X23-575_867_603___GEO_EN_005___RVTO_MARCO_LUNETA__B-GUSS_KW29___170714_SE376_ACC_141020_003.CATPart

Analyze made against this part file name.

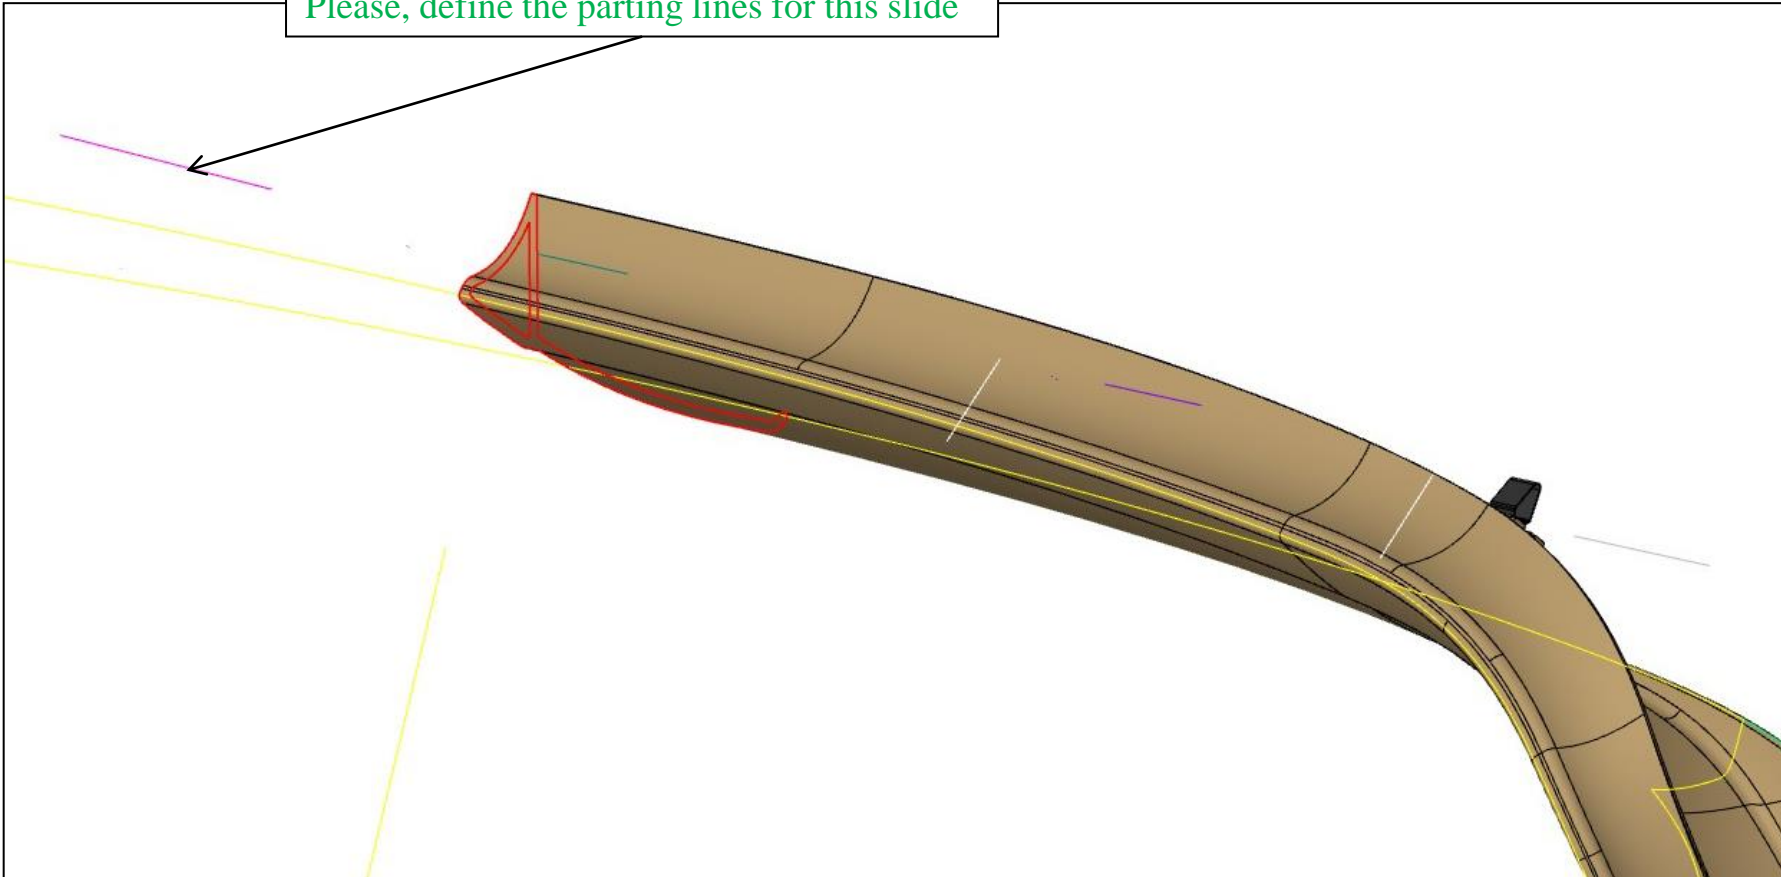
Please, define the parting lines for this slide
